AGENDA
DANIA BEACH CITY COMMISSION
HYBRID REGULAR MEETING
TUESDAY, SEPTEMBER 27, 2022 - 7:00 PM

A RESOLUTION OF THE CITY COMMISSION OF THE CITY OF DANIA BEACH, FLORIDA, APPROVING VARIANCE (VA-072-22) AND SITE PLAN (SP-034-22), SUBMITTED BY FIRST DANIA BEACH, LLC, FOR PROPERTY LOCATED AT

A0.2

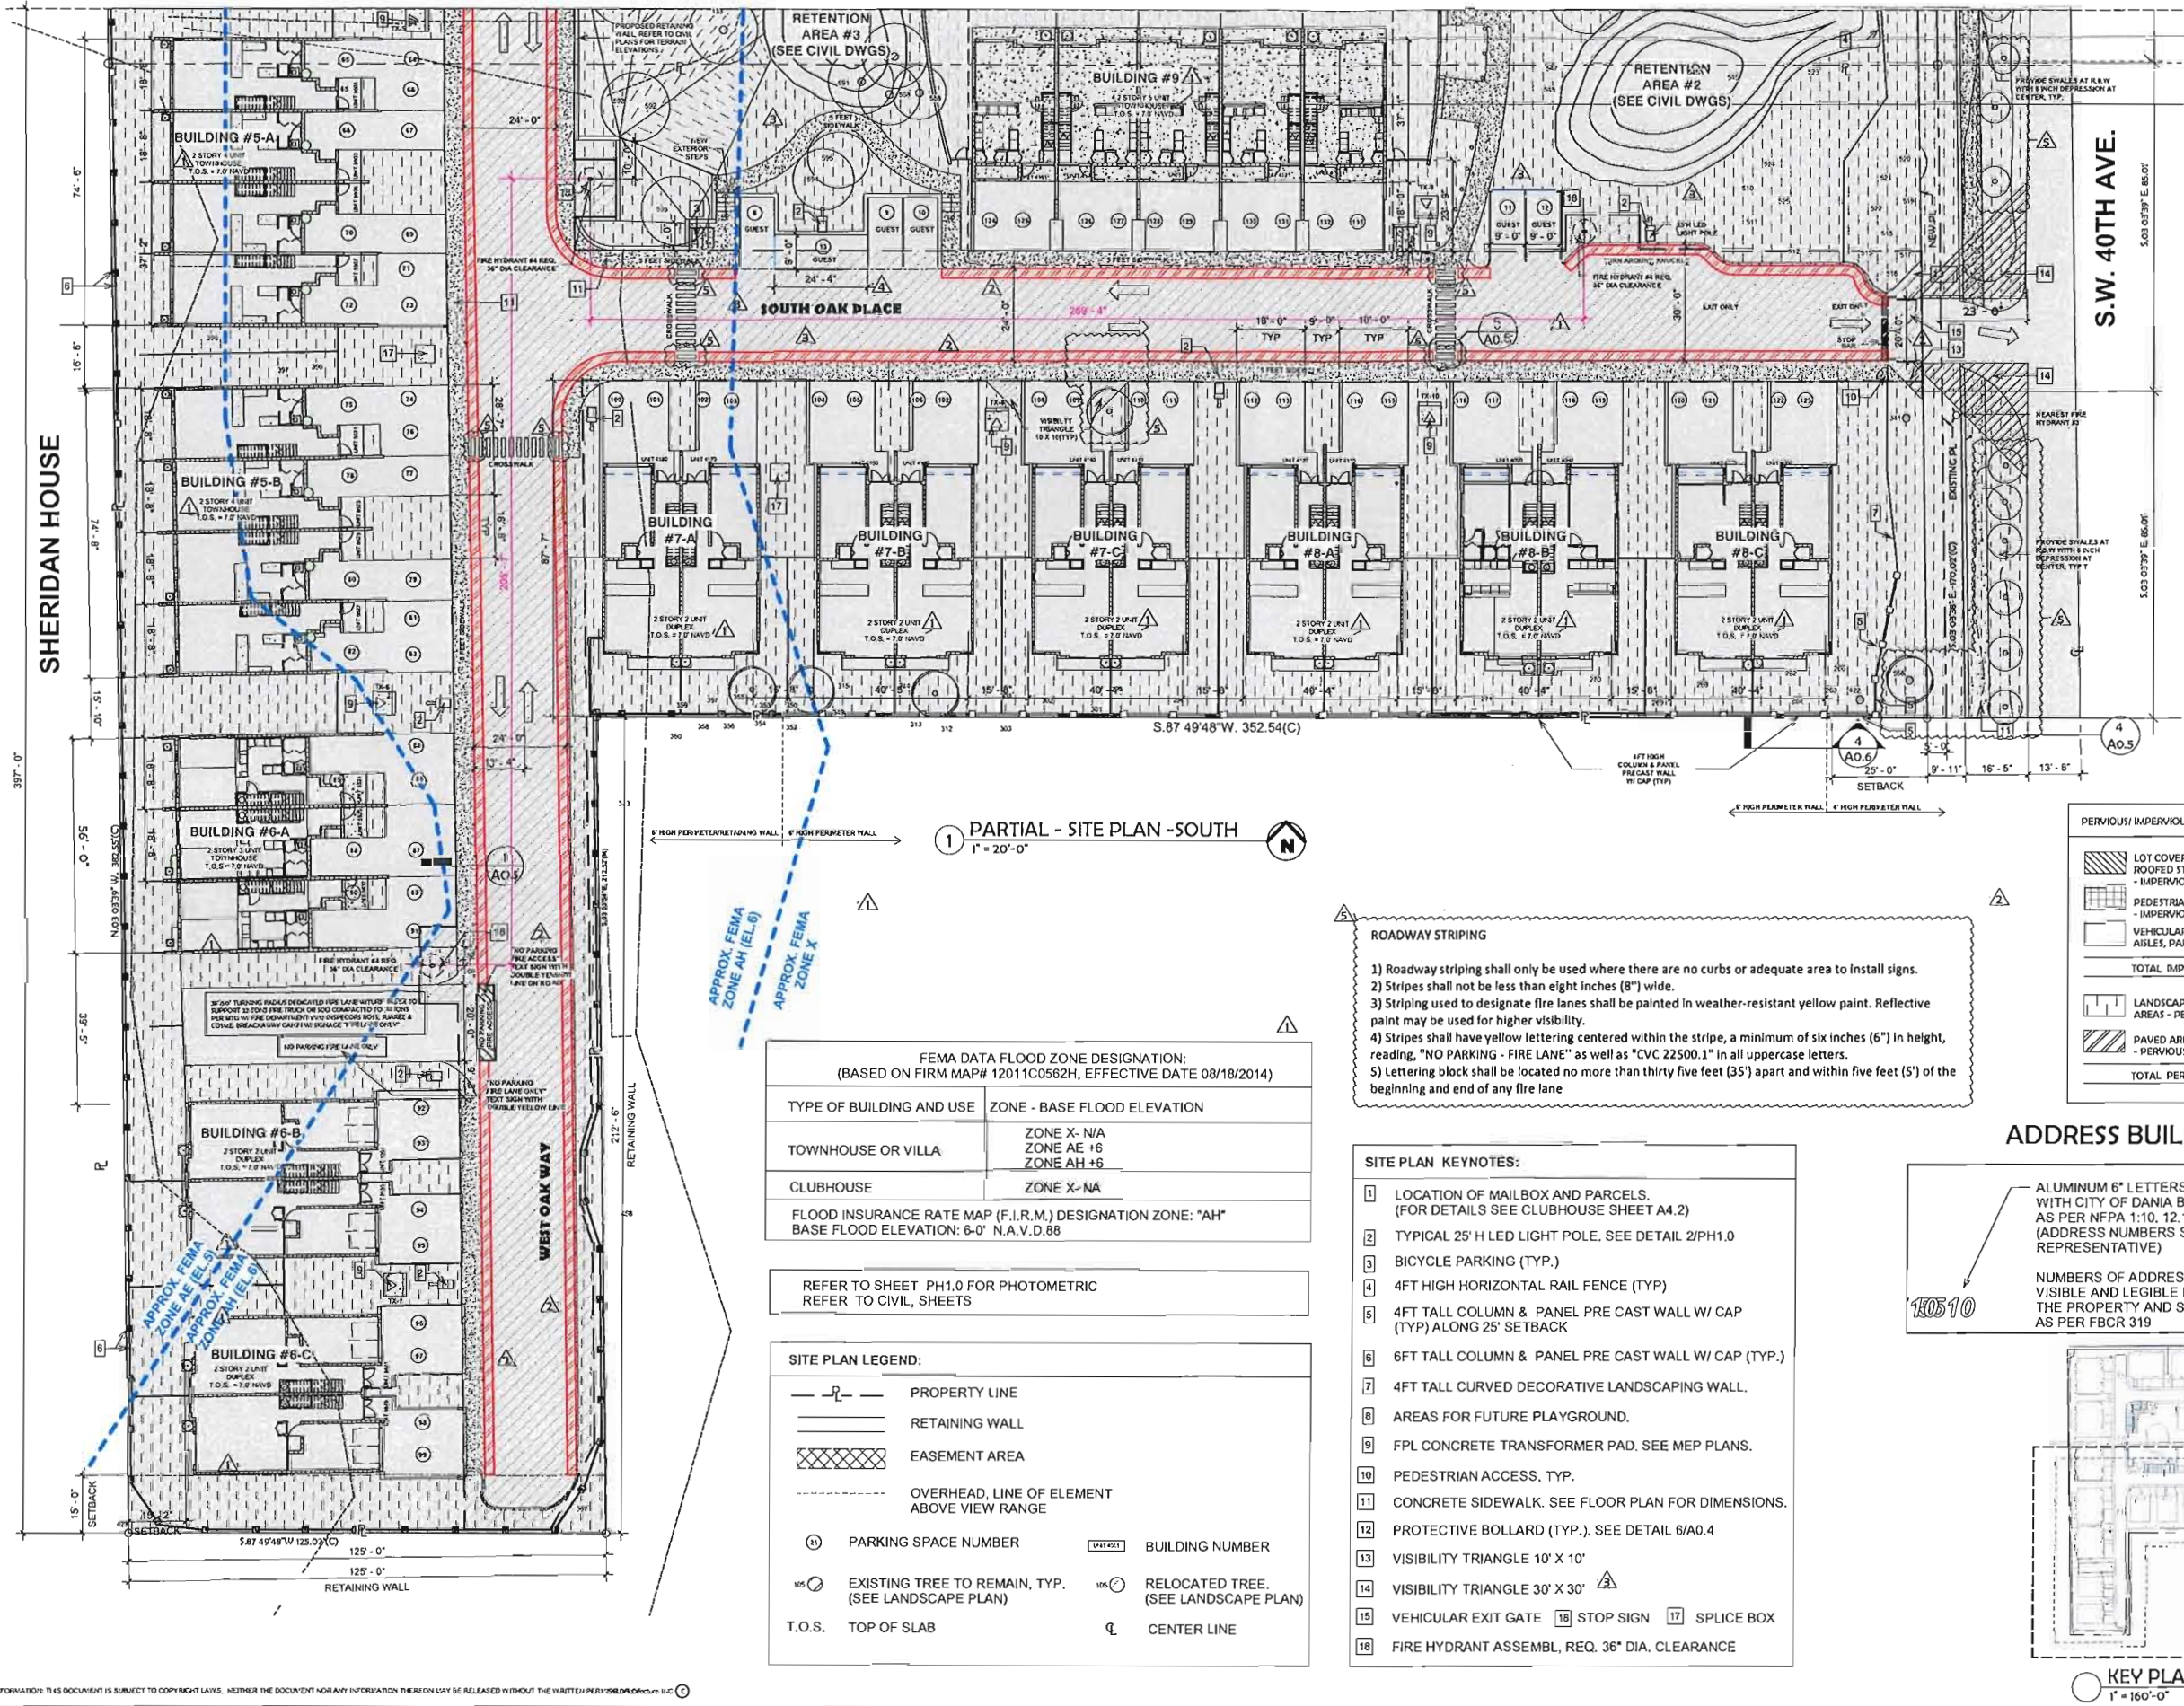
1. Plan Sheet A0.2, verify the colors to be utilize with for the fire lane with the City's Fire Department representative. (Roadway Striping Notes 3& 4)

2. Plan Sheet A0.2 Please revise Roadway Striping Note 5 to the intended length of separation. It currently reads "thirty-five feet (50')". Is it 35'? or 50'? Please clarify and revise the note accordingly.

3. Remove Fire Lane pavement markings that conflict with proposed marked crosswalks. Plan Sheets A0.2 and A0.3.

SHEET No:
A-201

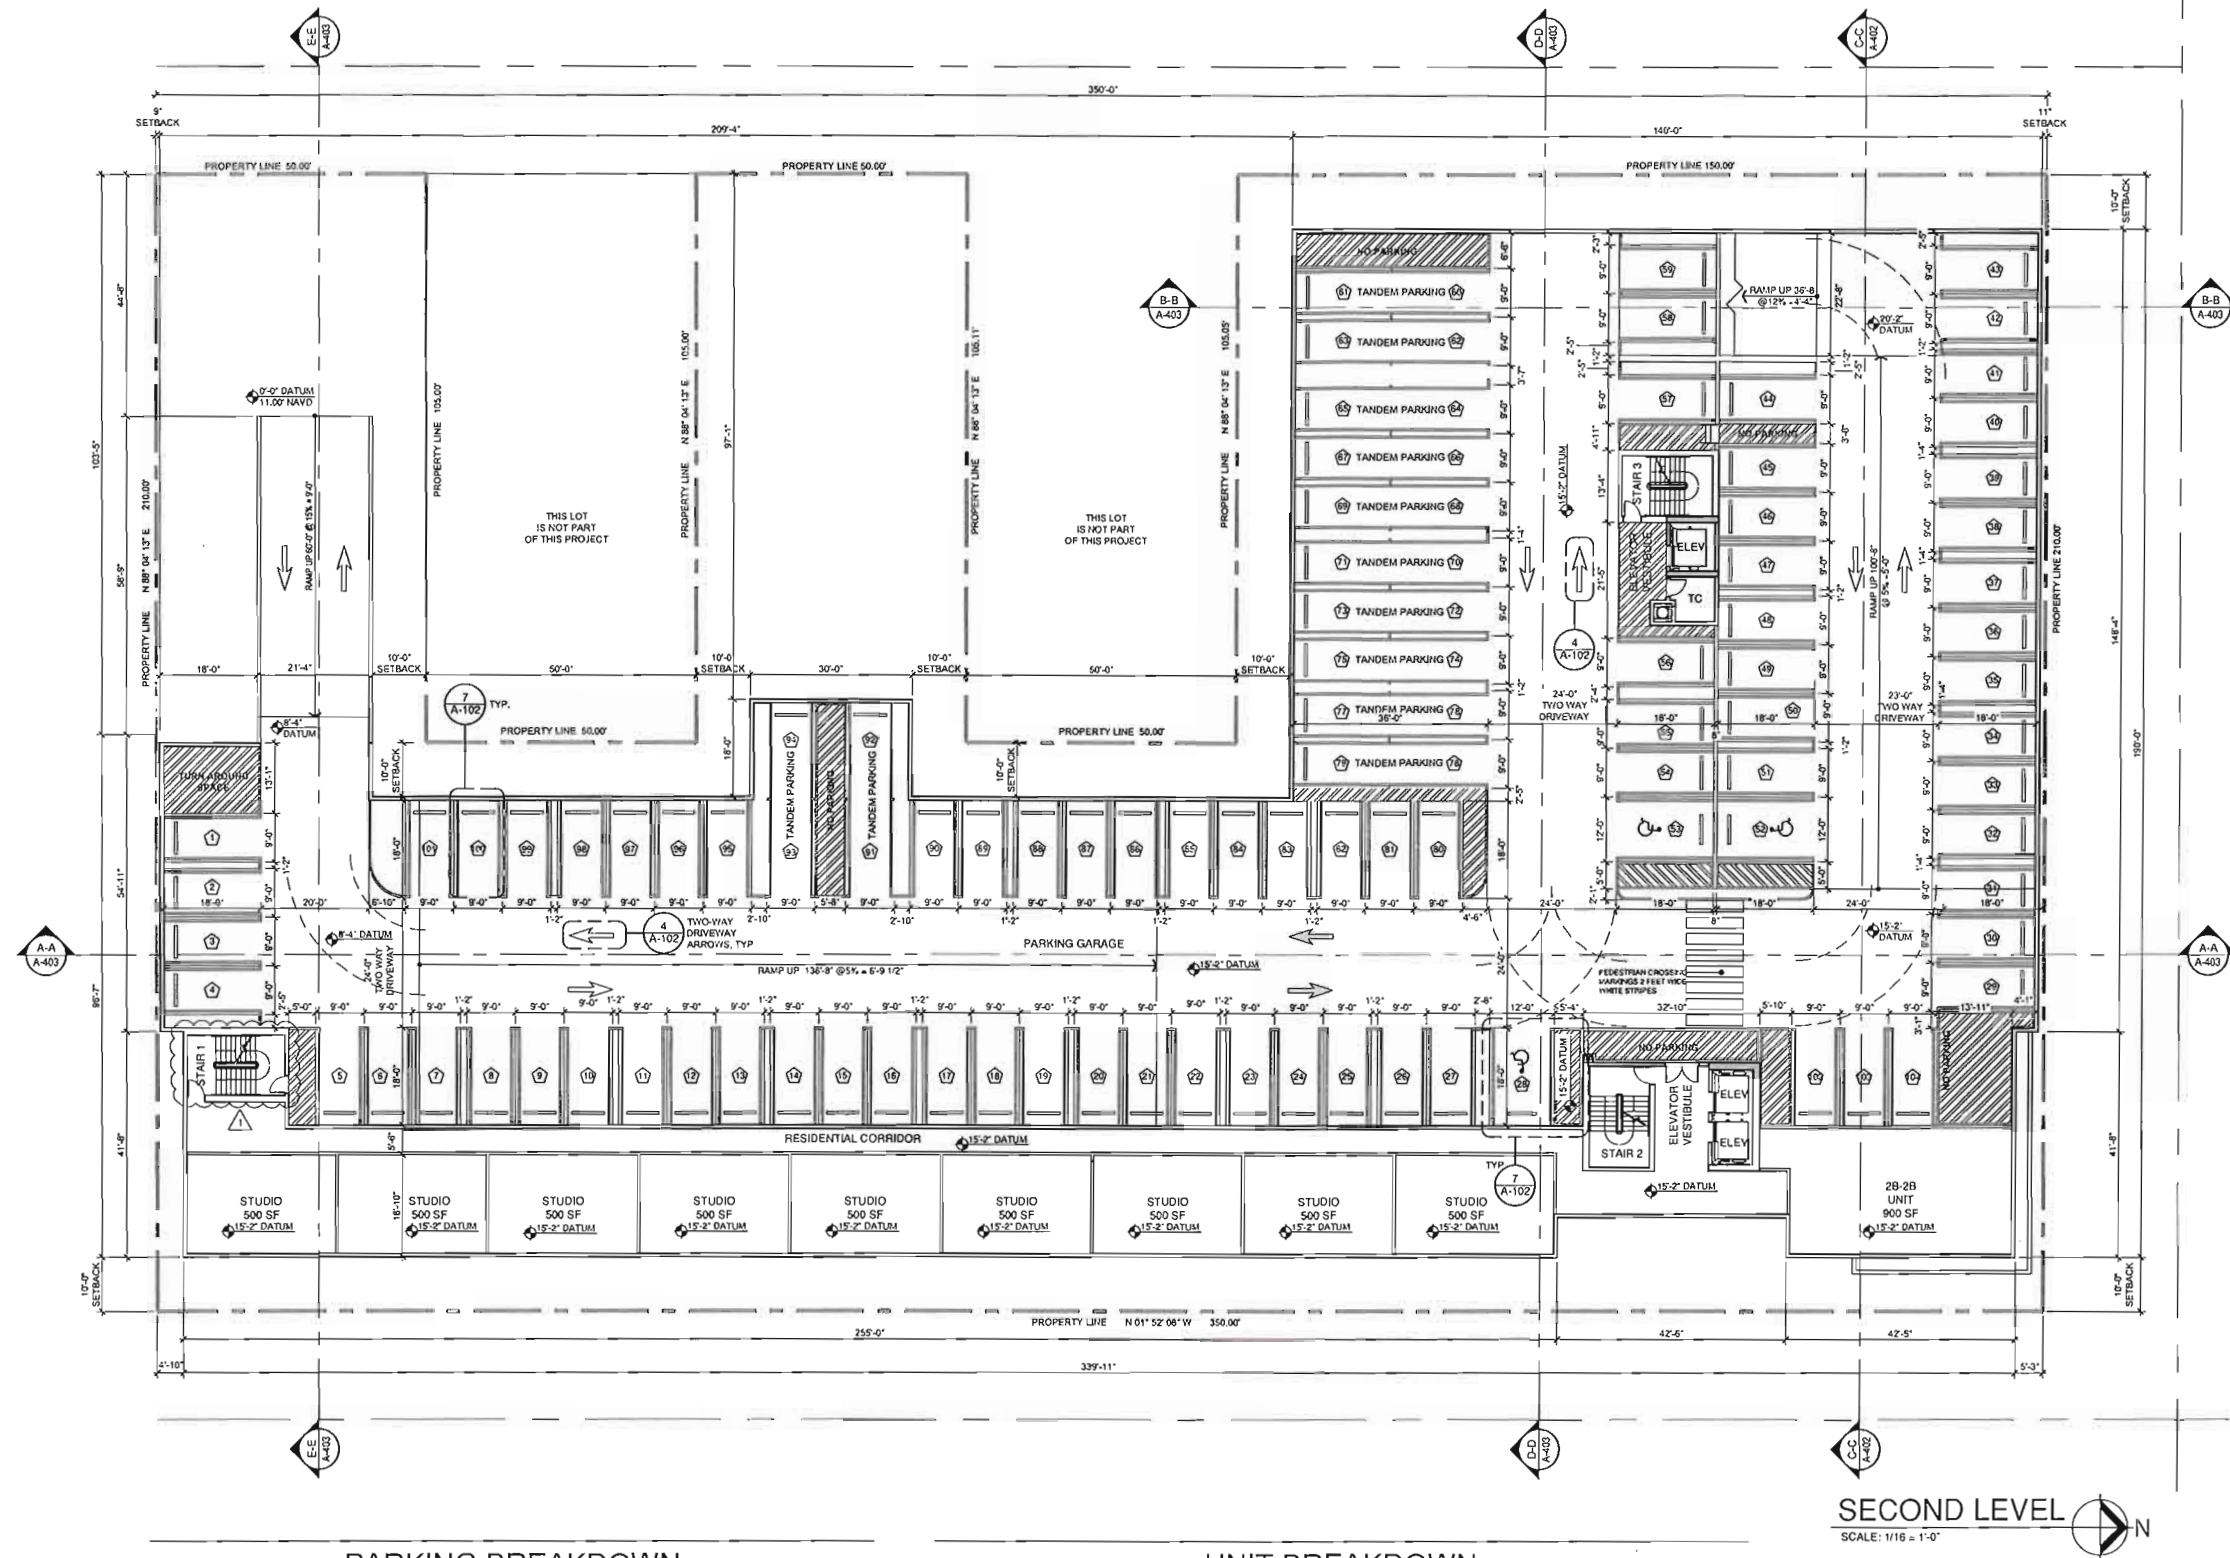
14. Per Section 635-50 (M), the location, dimensions and character of construction of proposed curb cuts, entrances and exiting, parking and loading areas (including number of parking spaces and loading spaces), pedestrian use areas, and vehicular use areas – Sheet A-201 Correct table to show 4 tandem spaces.

11. Site Circulation Mandatory	
Calvin, Giordano & Asso. Diana White 4/20/22 10:41 PM Express Workflow - 1	Please clarify the call-out labels at the parking garage access on plan sheet A-201 that read "20'-0" Two-way driveway" adjacent from each other. Having two driveways so close from each other generates multiple conflict points and safety concerns. Please address this issue.
Flynn Engineering John Kramer 5/26/22 1:39 PM Express Workflow - 1	Please clarify the call-out labels at the parking garage access on plan sheet A-201 that read "20'-0" Two-way driveway" adjacent from each other. Having two driveways so close from each other generates multiple conflict points and safety concerns. Please address this issue. RESPONSE: See updated Sheet (A-100). One of the driveways was removed.
Calvin, Giordano & Asso. Diana White 6/15/22 5:01 PM Express Workflow - 2	There are still some safety concerns with the proximity to the residential driveway at 121 SW 1st Court. No TIA has been provided for review to look at the volume of trips that the project access driveway will be handling. it seems that this will be the main point of access for the site and there may be some conflicts with vehicles in and out of these 2 driveways; since these are so close to each other. [Ver. 2] [Edited By Diana White]

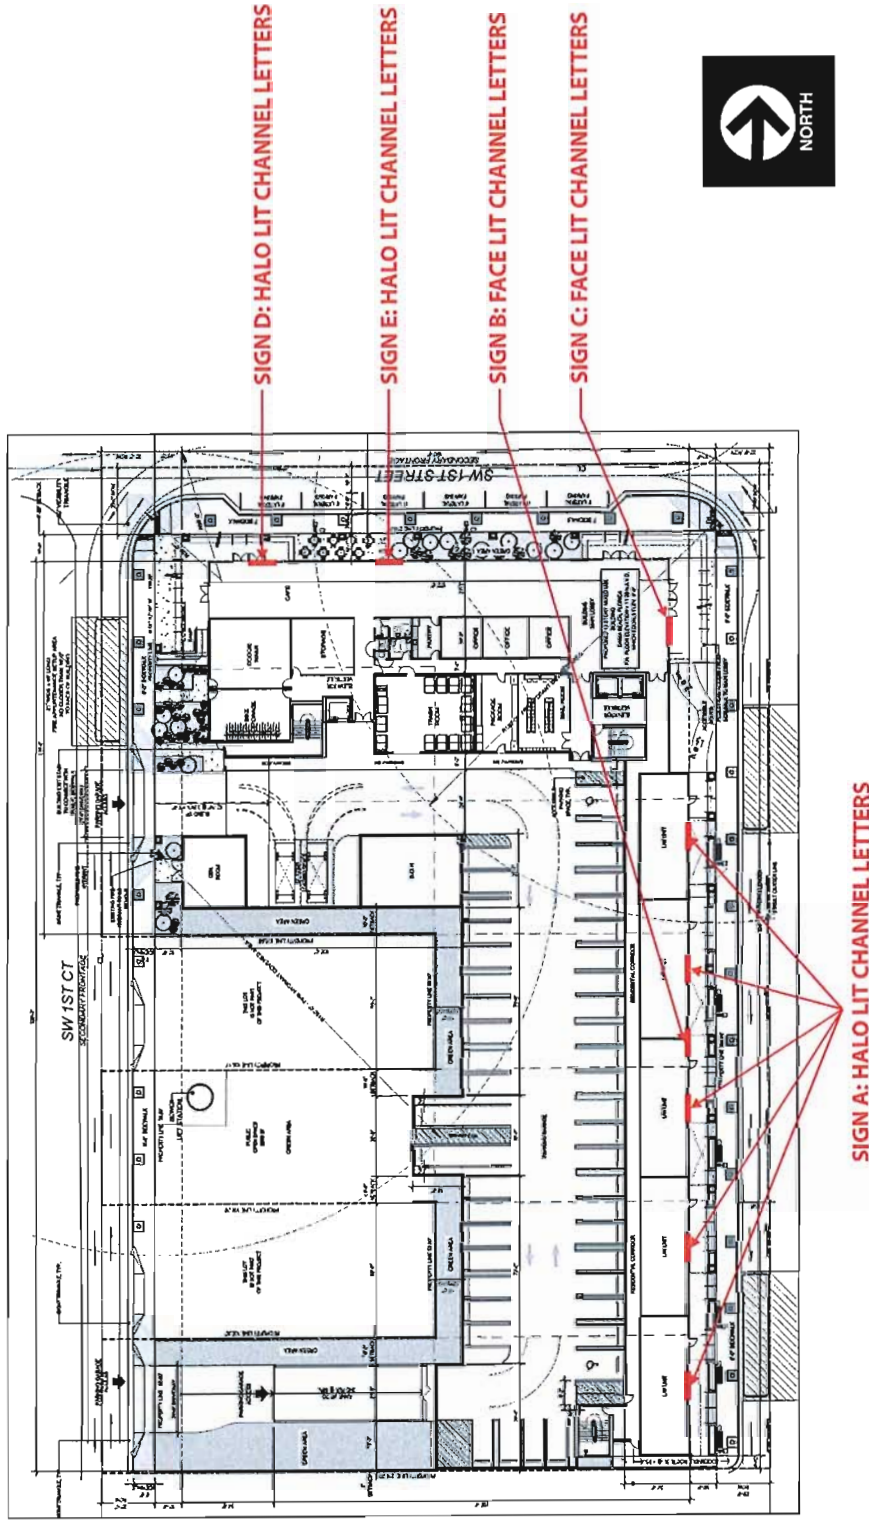
45. TIER 1 – Per Sec. 303-40(P) Step backs are measured from edge of building not property line. See Figure 303-9 entitled "Illustrating Upper Story Setbacks".

· 10' setback @ 6th floor required on all street frontages

· Setback = 12% of lot width or 15' @ 6th floor is required for all interior sides.
